7-H-21-HZ
APPLICATION FOR CERTIFICATE OF APPROPRIATENESS

1800 Jefferson Ave. 37917
Edgewood-Park City H

Staff Report

File Number: 7-H-21-HZ

Proposed home design

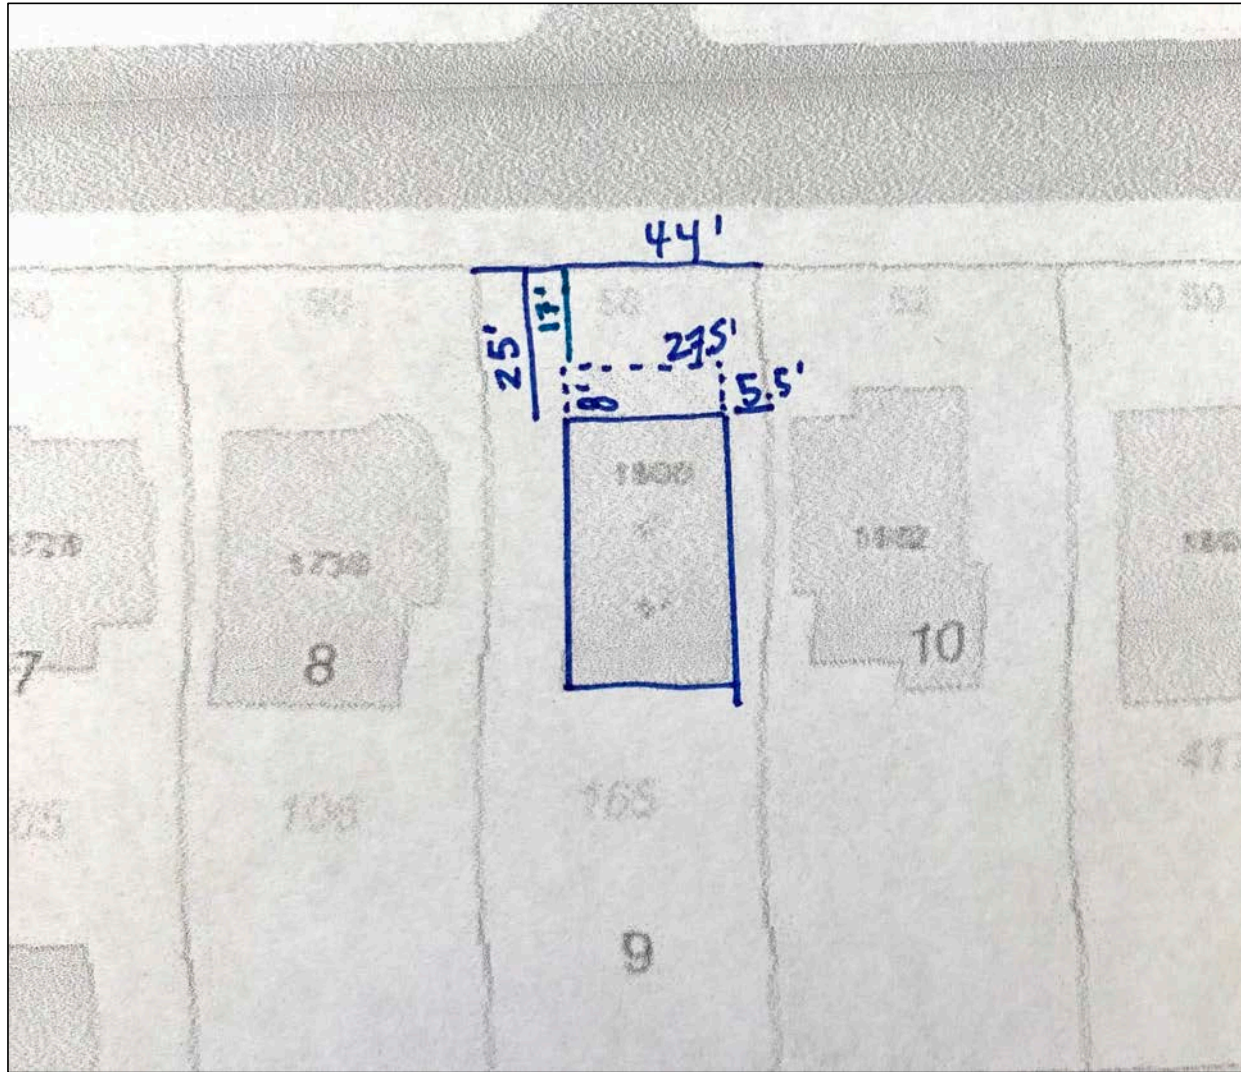
5. The proposed asphalt shingle roof cladding, wood lap siding on the gable field, fascia and trim to match the existing roof elements, and round wood columns meet the design guidelines for new porches. While replacing an existing wood porch with a concrete porch is not recommended in the guidelines, the proposed foundation is a new element and will be minimally visible from the right-of-way, at only 4" tall. In this application, a new concrete porch will not detract from the overall house's integrity. Final specifications for height of the porch roof, dimensions for portico gable, and fascia details should be submitted to staff for approval.

- 1) new west elevation window header to align with adjacent window, with specifications for window to be submitted to staff for approval, including placement and trim details;
- 2) final specifications for porch roof height, dimensions of portico gable, and fascia details to be submitted to staff.

Right side of house with non historic entrance to be demolished.

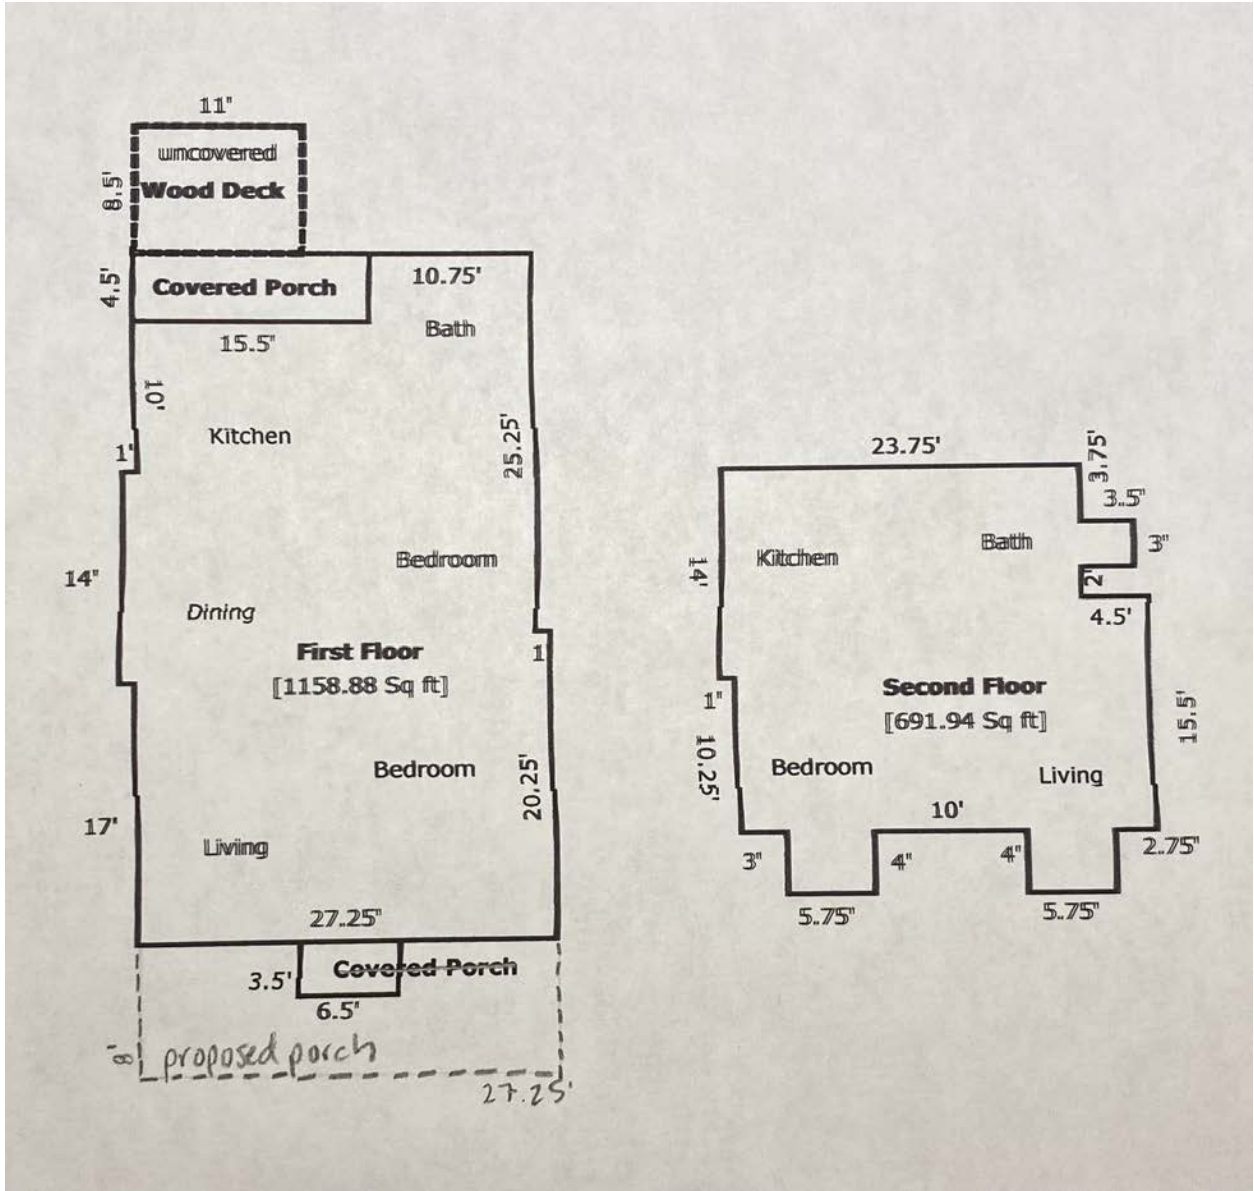
3. The secondary entry (and concrete access stair) on the west elevation is a non-historic modification which does not contribute additional character to the house and appropriate for removal. Installation of a double-hung wood window to match the size of the additional first-story west elevation windows is appropriate. The new window's header height should align with the existing first-story windows instead of being placed within the door opening. Final specifications for the new window, including placement and trim, should be submitted to staff for approval.
